Public Service
Company of Colorado

April 28, 1997
Fort St. Vrain
P-97029

**SUBJECT: Confirmatory Radiation Survey of Liquid Effluent Pathway,
Response to NRC Comment**

**EVALUATION OF AVERAGE ACTIVITY
IN 100 M² AREA AROUND FLAG 157
IN GROUP E EFFLUENT DISCHARGE PATHWAY AREA**

Figure 1

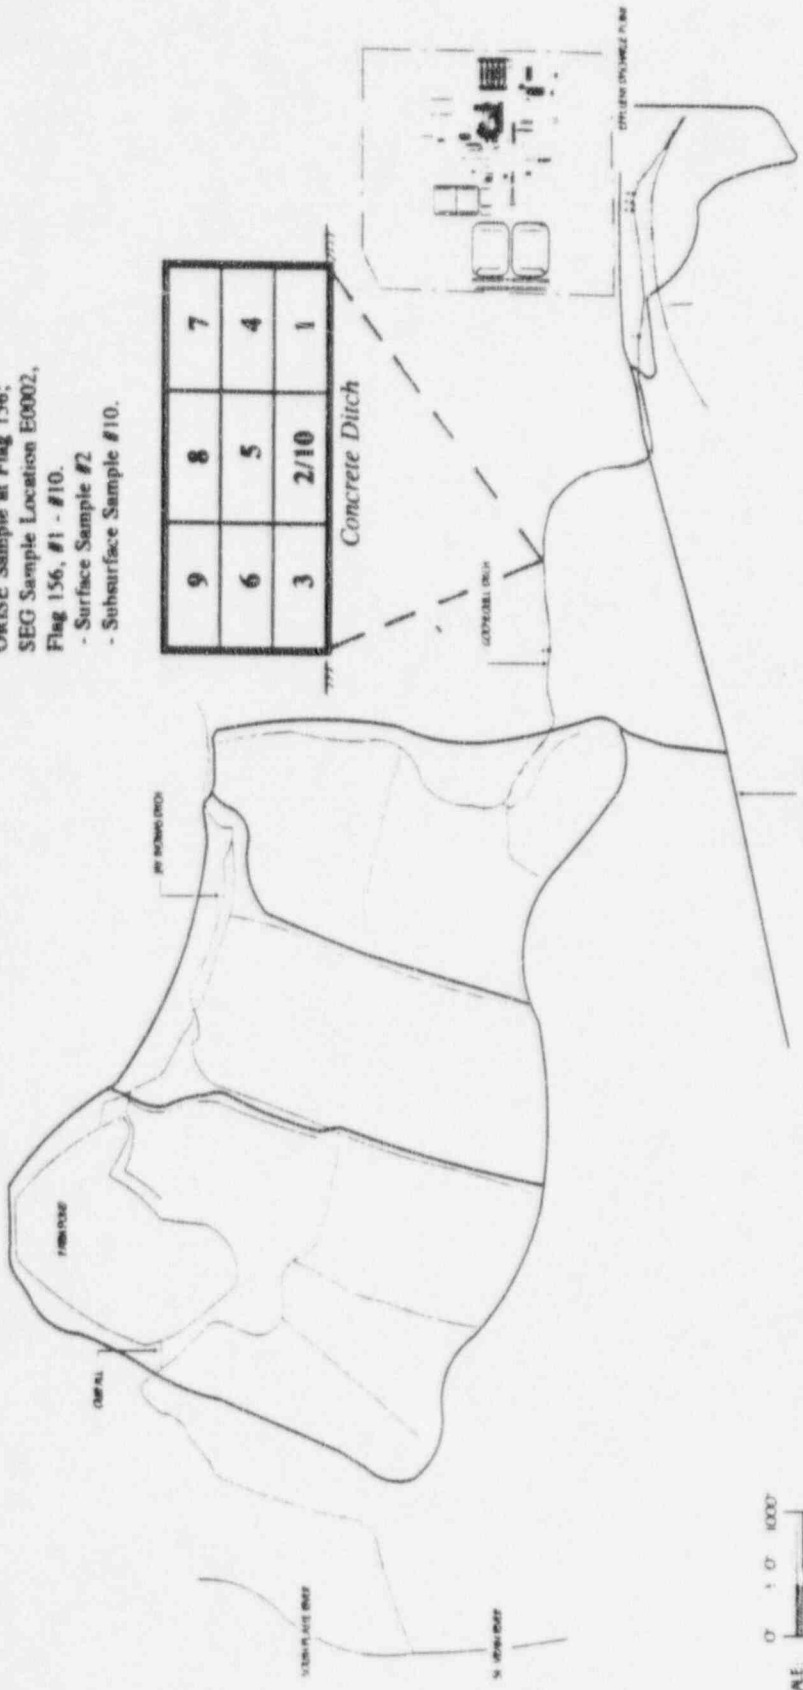
As part of the NRC's review of the Reference 2 submittal, the Oak Ridge Institute for Science and Education (ORISE) performed confirmatory surveys of the liquid effluent discharge pathway areas at Fort St. Vrain. As indicated in the referenced letter, ORISE identified one sample with residual activity that exceeds site guideline values. This sample, near location flag number 157, included activity where the sum of the fractions of nuclide concentrations to guideline values was 1.9. In accordance with guidance in Draft NUREG/CR-5849 and in the Reference 2 proposed plan for final radiation survey of the effluent pathway, samples whose sum of fractions exceeds 1.0 require evaluation to determine whether average contamination levels in the 100 m² area surrounding the elevated sample exceed the guideline values.

SEG collected investigation samples from each ORISE sampling location on April 2, 1997. The SEG samples were archived so that if any ORISE sample showed elevated results the average concentration within the surrounding 100 m² area could be determined in accordance with FSV procedures and protocols. A SEG surface sample was collected from the soil surrounding the ORISE location, effectively widening the hole. A 100 m² grid was established around the ORISE sample location and eight additional surface samples were obtained in accordance with Fort St. Vrain final survey procedures. A SEG subsurface soil sample (6 to 12 inches below the surface) was collected from the ORISE sample location. SEG samples labeled as Flag #156 correspond to the ORISE sample labeled as Flag #157 (the selection of the nearest flag marker was subjective). Figure 1 shows the investigation sample location.

The elevated area (area exceeding the guideline value) was determined to be confined to one grid representing 11.11 m². The maximum value by which any sample could exceed the release criteria is therefore 3.0. The weighted mean SOF from the 100 m² investigation area, determined in accordance with the procedure, is 0.23.

The elevated area (area exceeding the guideline value) was determined to be confined to one grid representing 11.11 m². No individual sample exceeded the guideline value by a factor of 3.0.

The weighted mean "sum of fractions", SOF for the 100 m² area surrounding the location identified by ORISE was determined to be less than 1.0. The weighted mean SOF for Flag 156/157 was 0.23 equating to 2.3 mrem Total Effective Dose Equivalent.
